# Proposal how to structure the RESS safety requirements

Status: 07.01.2011

Blue	= German VDA, German TÜV's, Battery Manufacturer
Red	= TÜV Süd
Green	= Mercedes
Brown	= SP Technical Research Institute of Sweden
Purple	= JAPAN (JASIC)
UN Test	= UN 38.3 Requirements

Figure 6 — Dewing cycle

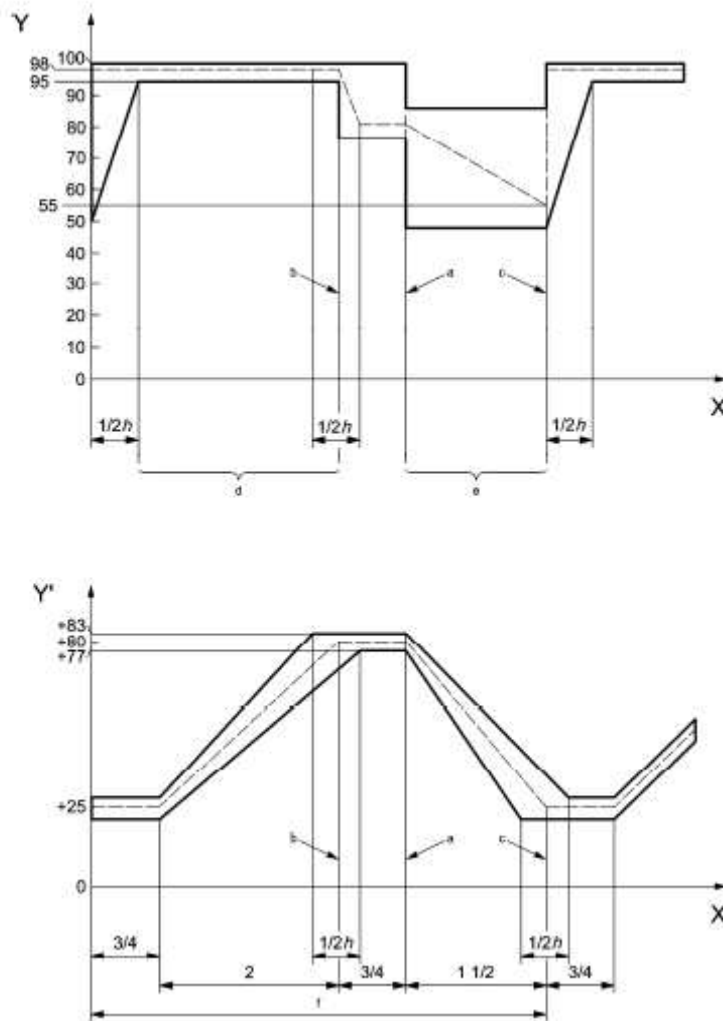
**REMARKS: Critical phenomenon most likely happens under the humidity test procedure is short circuit at external of the cell. Therefore, specific test procedure for humidity will not be necessary.**

According to ISO16750-4 § 5.6 test3 (same as in ISO 12405 but ISO 12405 is still a DIS).  
SOC 50%,
